## QUALITY ASSURANCE -- NON-CONFORMANCE REPORT

**Report No:** NCR-000998

<b>Welding</b>	<b>Concrete</b>	<b>Other</b>	
<b>Welding</b>	<b>Curing</b>	<b>Procedural</b>	<b>Bridge No:</b> 34-0006
<b>Joint fit-up</b>	<b>Coating</b>	<b>Other</b>	<b>Component:</b> OBG Suspender Bracket 110E
<b>Procedural</b>	<b>Procedural</b>	<b>Description:</b> Missed MT transverse indication

**Reference Description:** QA found a missed MT transverse indication after ZPMC had tested and accepted the weld at Suspender Bracket 110 East

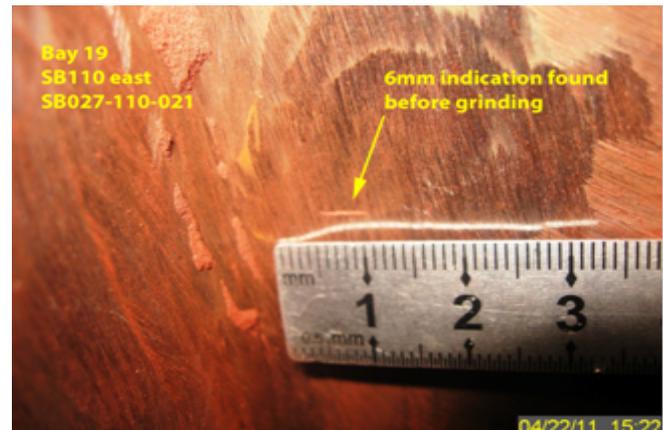
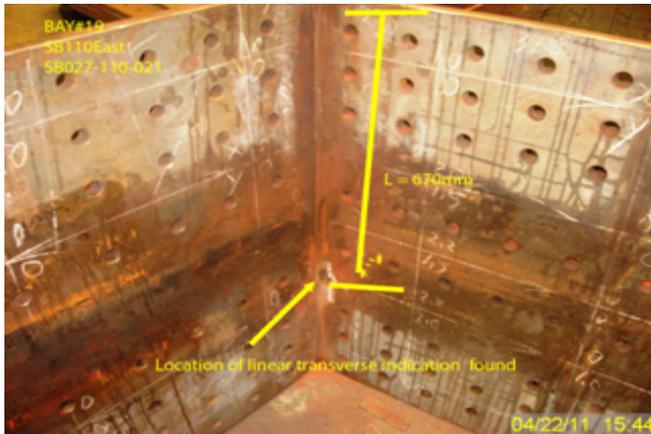
During the Quality Assurance (QA) Magnetic particle Testing (MT) review of welds located on OBG Suspender bracket SB110 East, this QA Inspector discovered the following issues:

- One transverse indication measuring approximately 6mm was found in weld ID SB027-110-021.
- In grinding the surface of the weld, the transverse indication is also present, measuring about 15mm.
- The weld is a 12mm Partial joint penetration (PJP) T joint, joining the Edge plate (X65W) to the Side plate (X64DD).
- The Y Location is 670mm from the edge of side plate
- The OBG Suspender bracket is located in BAY#19.
- This indication is clearly marked on the material on/near the weld.
- This weld joint is Non-Seismic performance critical (Non-SPCM).
- The Notice of Witness Inspection Number (NWIT) is 8899.
- The indication is located within an area that has been previously tested and accepted by ZPMC Quality Control (QC).

AWS D1.5 (02) Table 6.8 – Specifies the maximum length indication allowed is approximately 3mm for a 12mm weld.

ZPMC acknowledged this problem and has issued an internal NCR. This indication has been removed, repaired and re-tested to be acceptable. ZPMC is providing the NDT record and is requesting closure of this NCR.

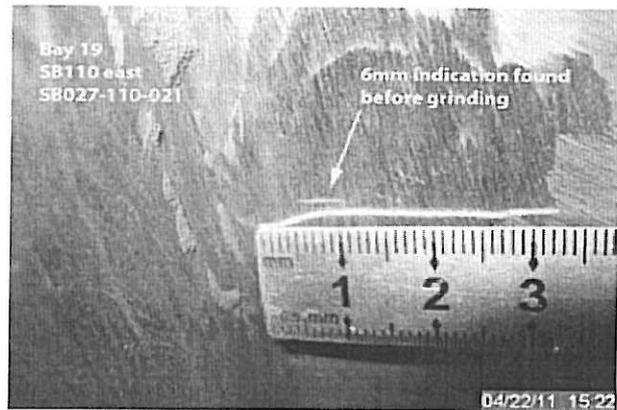
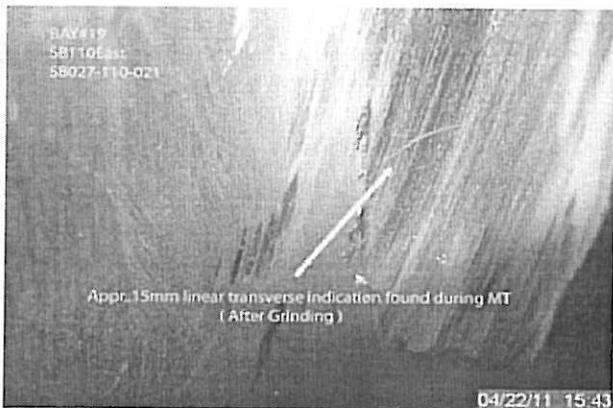
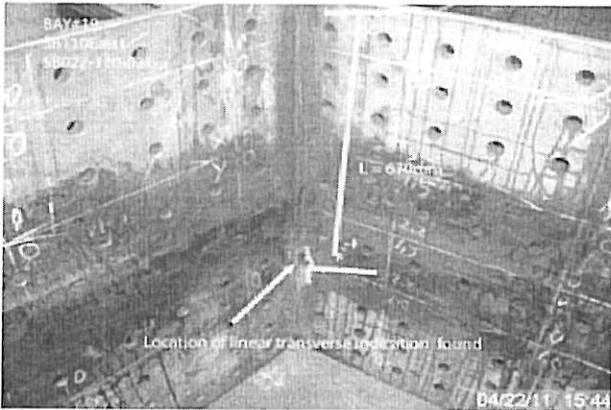
During the Quality Assurance (QA) Magnetic particle Testing (MT) review of welds located on OBG Suspender bracket SB110 East, this QA Inspector discovered the following issues:

- One transverse indication measuring approximately 6mm was found in weld ID SB027-110-021.
- In grinding the surface of the weld, the transverse indication is also present, measuring about 15mm.
- The weld is a 12mm Partial joint penetration (PJP) T joint, joining the Edge plate (X65W) to the Side plate (X64DD).
- The Y Location is 670mm from the edge of side plate
- The OBG Suspender bracket is located in BAY#19.
- This indication is clearly marked on the material on/near the weld.
- This weld joint is Non-Seismic performance critical (Non-SPCM).
- The Notice of Witness Inspection Number (NWIT) is 8899.
- The indication is located within an area that has been previously tested and accepted by ZPMC Quality Control (QC).

AWS D1.5 (02) Table 6.8 – Specifies the maximum length indication allowed is approximately 3mm for a 12mm weld.

Contractor will repair the weld indication and provide the NDT report to prove the weld is acceptable.

Contractor repaired the weld, and provided the NDT report. The NDT report proved the weld is acceptable. Internal NCR issued.
